Amendments to the Drawings:

REMARKS/ARGUMENTS

Appln No. 10/721,474
Response to OA of 3-16-2006
ANNOTATED MARKED-UP DRAWING

Fig. 4

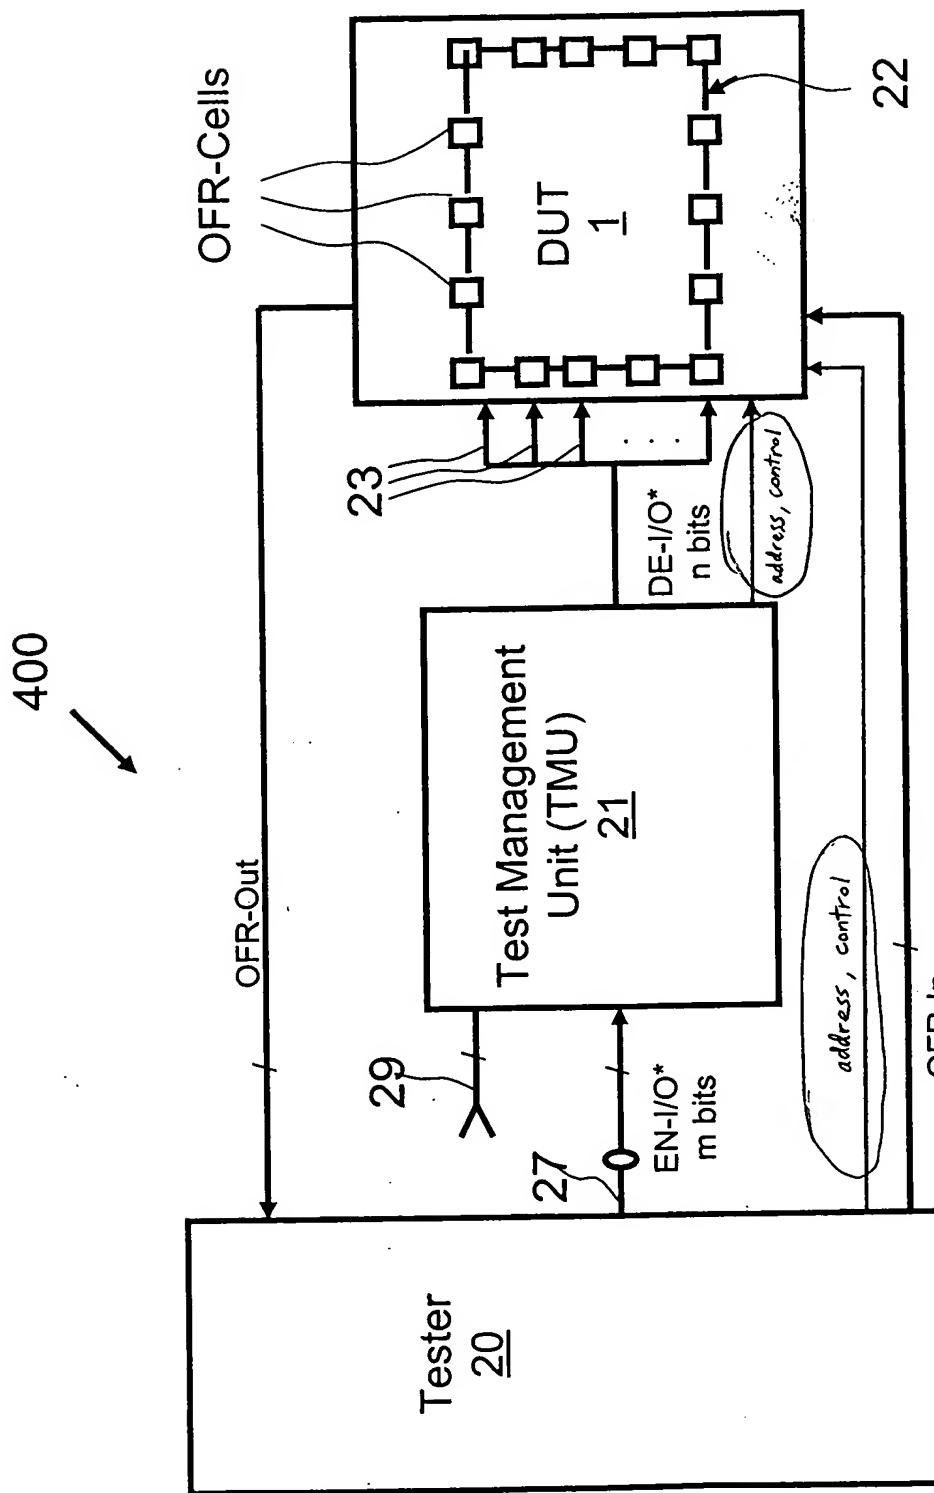
Fig. 4 has been amended to show features of the invention specified in claims 13 and 14 of the present application.

It should be noted that the subject matter of claim 13 is shown in amended Fig. 4 and discussed in paragraphs [20]-[23] of the present application. In addition, the subject matter of claim 14 is shown in Figs. 4 and 12 and discussed in paragraphs [20]-[23] and [35] of the present application.

Fig. 11

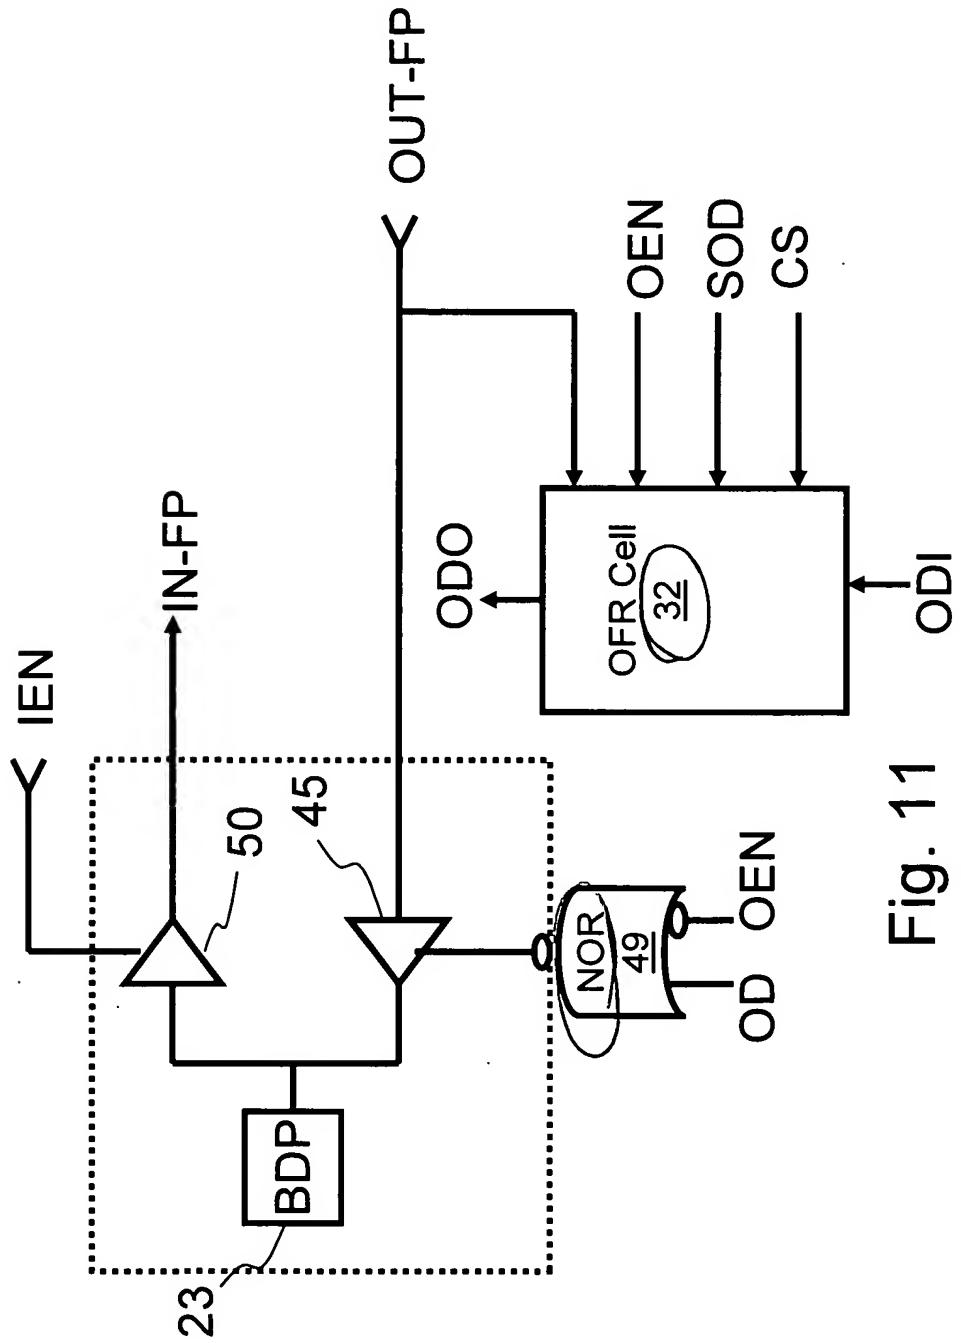
Fig. 11 has been amended to correct informalities.

Fig. 12
1004

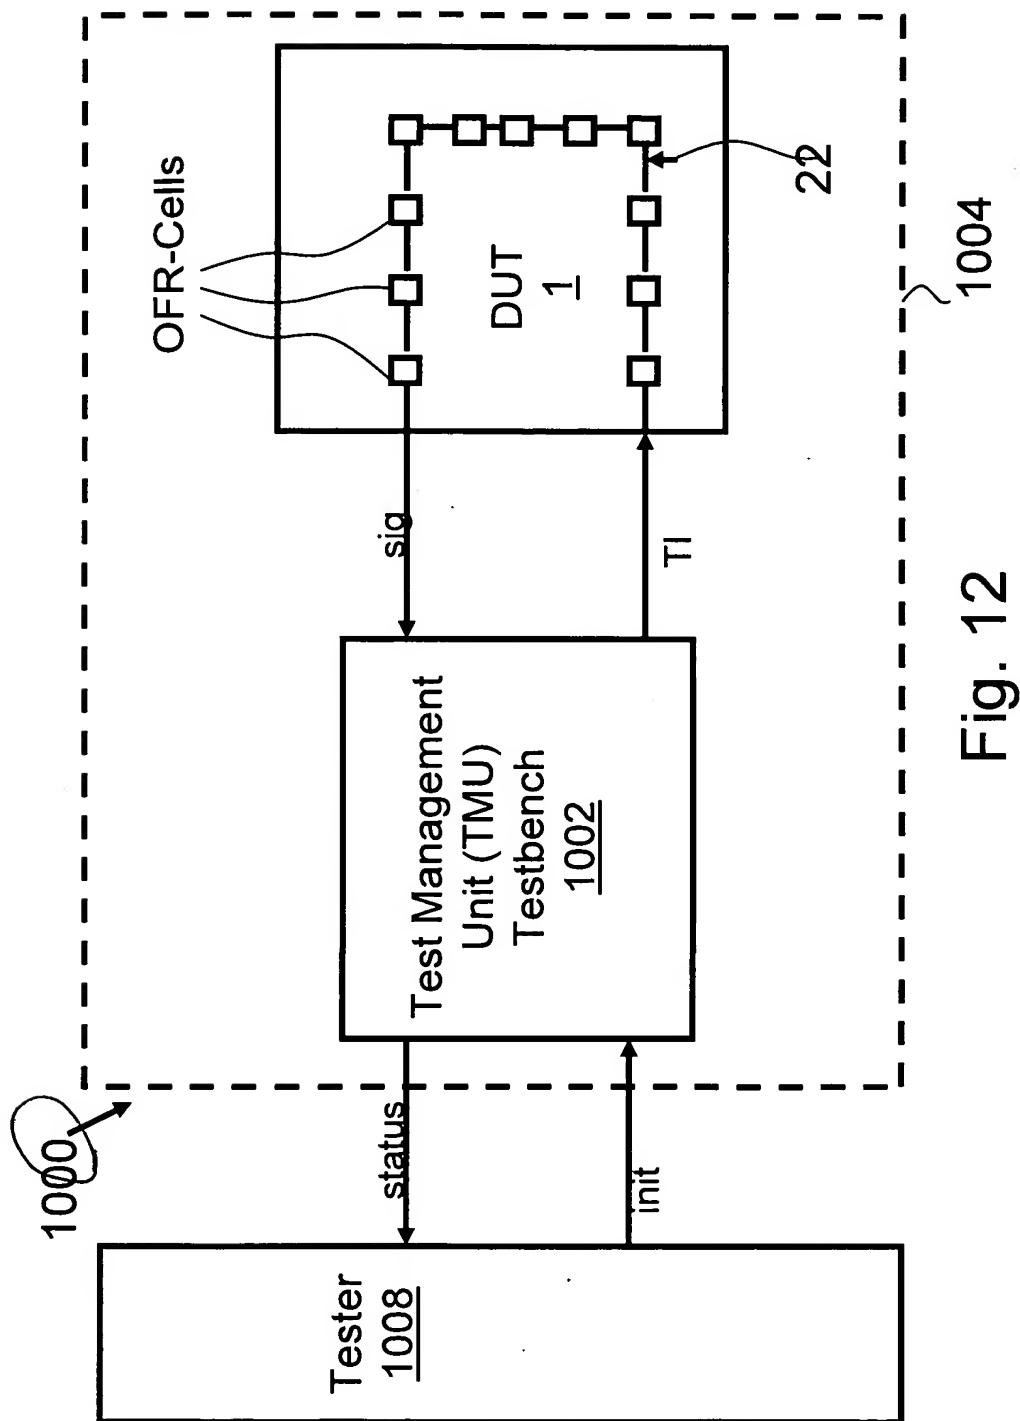
The specification and Fig. 12 have been amended to correct informalities.
